Pleasant Grove Community Church: Preliminary Plan No.120130160

**Pleasant Grove Community Church: Preliminary Plan No.120130160** Request to create a lot from Parcel 088 on Tax Map FX122 for the construction of an 8,600 square foot, 200 seat, church; located at 11307 Mountain View Road, approximately 700 feet west of Johnson Drive; 4.02 acres; R-200 and Rural Village Overlay Zone; Damascus Master Plan.

**Staff Recommendation:** Approval with Conditions

Figure 3 – Preliminary Plan

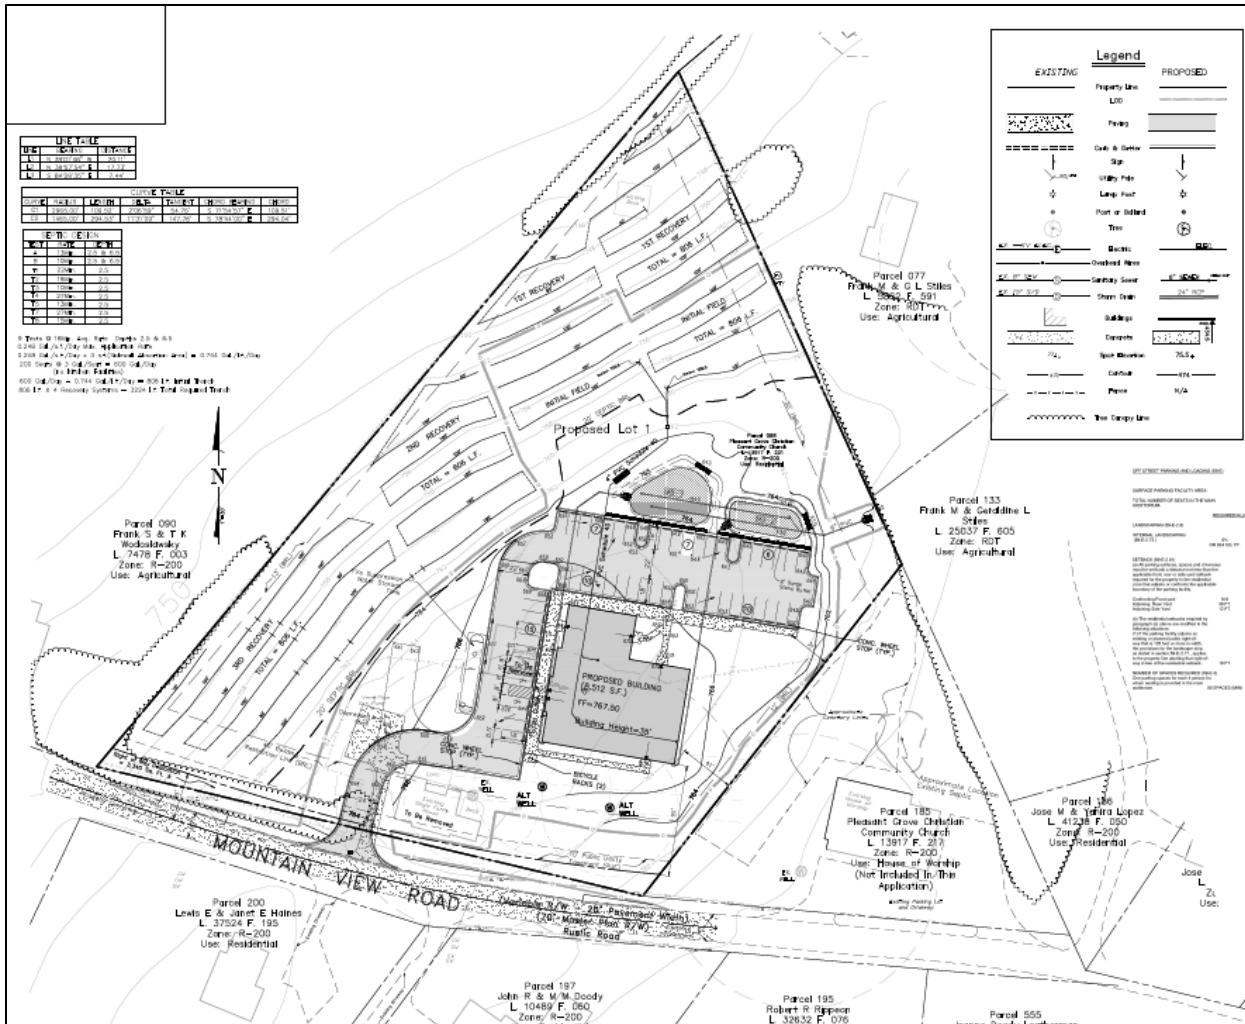
Dedication of 3,388 square feet of land along the Property's frontage is required to achieve the full master planned right-of-way width recommended for Mountain View Road. The Property is within the W-6 and S-6 water and sewer service categories, respectively. The new structures will be served by an on-site private well and septic system, to be constructed in the locations shown on the Preliminary Plan (Attachment A).

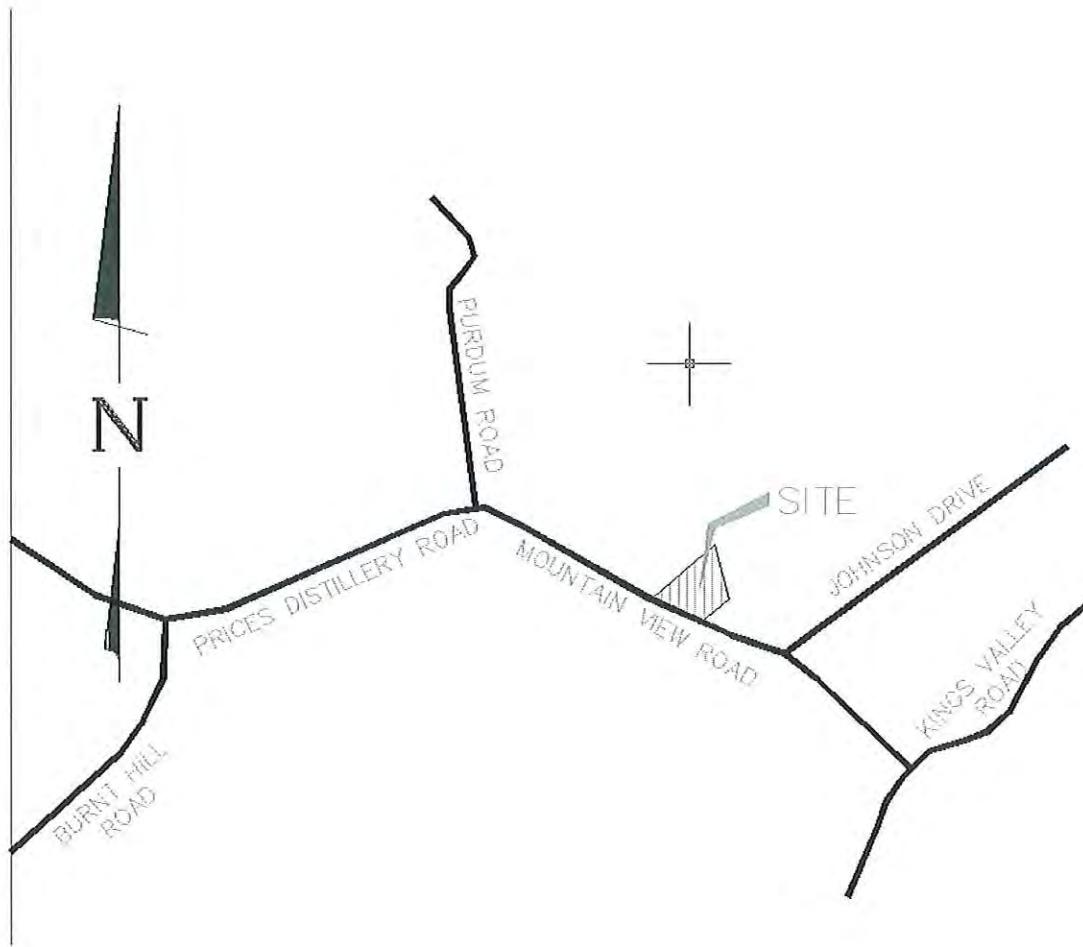
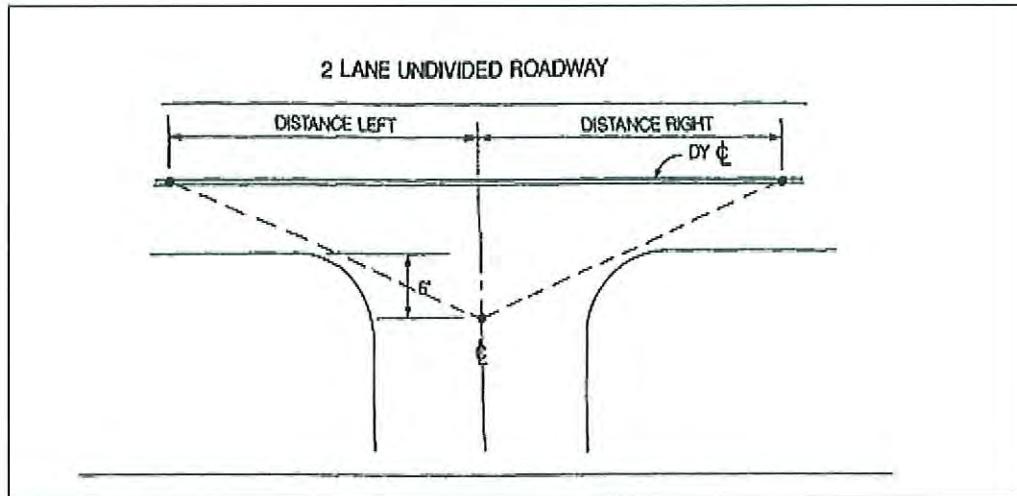
The proposed driveway for the referenced project fails to meet the sight distance requirements for the posted speed limit of 40 MPH under existing conditions. Shoulder grading and vegetation clearing will be needed in order to meet these requirements. It is, however, in our professional opinion that once shoulder improvements are completed, the sight distances requirements will be met satisfactorily. Please feel free to contact me if you have any questions or require any additional information. I hereby certify that this document was prepared or approved by me, and that I am a licensed Professional Engineer under the laws of the State of Maryland, License No. 14979, Expiration Date: 07-02-14
